RENESAS TECHNICAL UPDATE

Product Category	Standard Logic IC		Document No.	TN-WLG-A001A/E	Rev.	1.00
Title	The change of tray packing wafer protection seat for wafer delivery products		Information Category	Technical Notification		
Applicable Product	Standard Logic IC	Lot No.	Reference Document	Nothing		
		Since May, 2014

Wafer delivery products tray packing outline chart

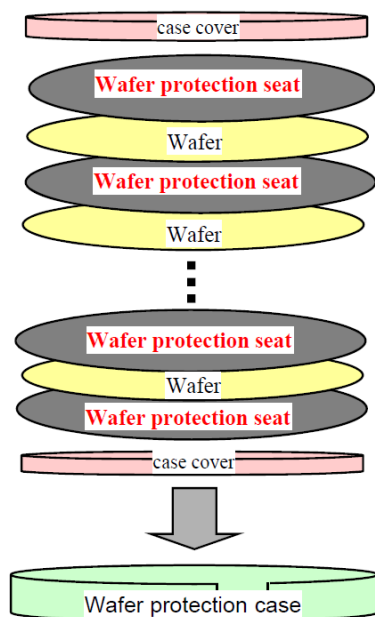
Content of change The wafer protection seat and the wafer protection case are changed.

Before change	After change
Wafer Protection seat	Front elevation	 Gray (Electroconductive olefine resin)	 Black (Carbon polyethylene)
	Cross section	(Non Emboss)  100um	(Emboss)  250um 100um
Wafer Protection case	Height	 15mm	 19mm
